POLICY REPORT
DEVELOPMENT AND BUILDING

Report Date: April 4, 2017
Contact: Susan Haid
Contact No.: 604.871.6431
RTS No.: 11994
VanRIMS No.: 08-2000-20
Meeting Date: May 2, 2017

TO: Vancouver City Council
FROM: General Manager of Planning, Urban Design, and Sustainability
SUBJECT: Miscellaneous/Minor Amendments to the Marpole Community Plan

Map of areas subject to modelling error amendments

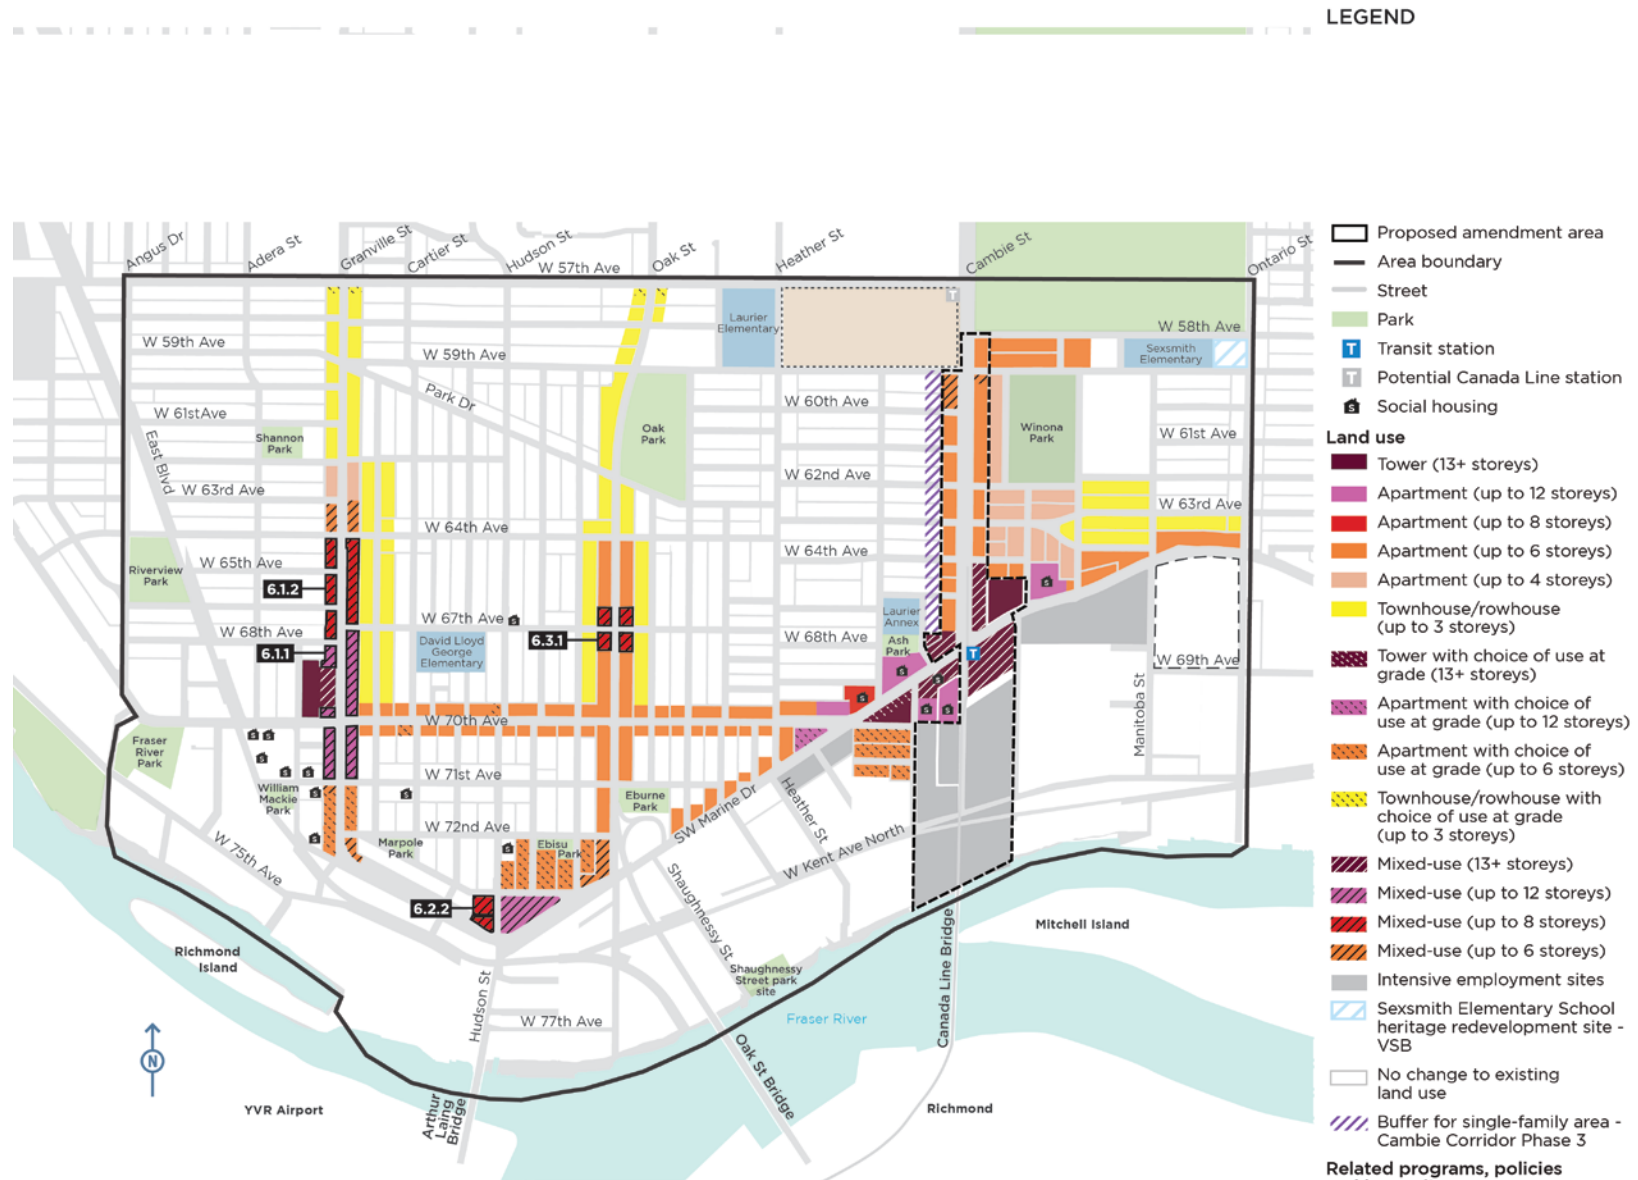
Through staff review of several rezoning enquiries on sites located in strategic commercial areas along Granville Street, Oak Street, and Hudson Street, a number of minor issues have arisen regarding the intended built form for those areas in the Plan (see Appendix A). These issues include incorrect density provisions due to modelling errors, and lack of clarity around appropriate tower floor plate size.

6.1.1 Mixed use (up to 12 storeys)	FSR: up to 3.0	FSR: up to 3.5 with consideration for an increase for developments that incorporate commercial/office space above the first floor. A minimum 0.5 FSR of commercial floor area will be required to achieve additional density beyond 3.5 FSR.	Adjust density to facilitate intended built form and encourage inclusion commercial floor space, noting lack of floor space exclusions for office developments result in greater FSR.
	Floor plates above the podium should not exceed 6,300 square feet.	Move to <i>Chapter 7 - Built Form Guidelines</i> : Floor plates above the podium are generally expected to be modest in size - approximately 4,000 square feet to 5,500 square feet. Floor plates above the podium level should not exceed 6,300 square feet on any site.	Current floor plate maximum of 6,300 square feet set out in the Plan suggests that this may be achievable on any site, which is not accurate. More explanation required for better clarity.

6.1.2 Mixed use (up to 8 storeys)	FSR: up to 3.0	FSR: up to 3.0 with consideration for an increase for developments that incorporate commercial/office space above the first floor. A minimum 0.5 FSR of commercial floor area will be required to achieve additional density beyond 3.0 FSR.	Adjust density to facilitate intended built form and encourage inclusion commercial floor space, noting lack of floor space exclusions for office developments result in greater FSR.
Lower Hudson Sub-Area

6.2.2 Mixed use (up to 8 storeys)	FSR: up to 3.0	FSR: up to 3.0 with consideration for an increase for developments that incorporate commercial/office space above the first floor. A minimum 0.5 FSR of commercial floor area will be required to achieve additional density beyond 3.0 FSR.	Adjust density to facilitate intended built form and encourage inclusion commercial floor space, noting lack of floor space exclusions for office developments result in greater FSR.
Oak Sub-Area

6.3.1 Mixed use (up to 8 storeys)	FSR: up to 3.0	FSR: up to 3.0 with consideration for an increase for developments that incorporate commercial/office space above the first floor. A minimum 0.5 FSR of commercial floor area will be required to achieve additional density beyond 3.0 FSR.	Adjust density to facilitate intended built form and encourage inclusion commercial floor space, noting lack of floor space exclusions for office developments result in greater FSR.
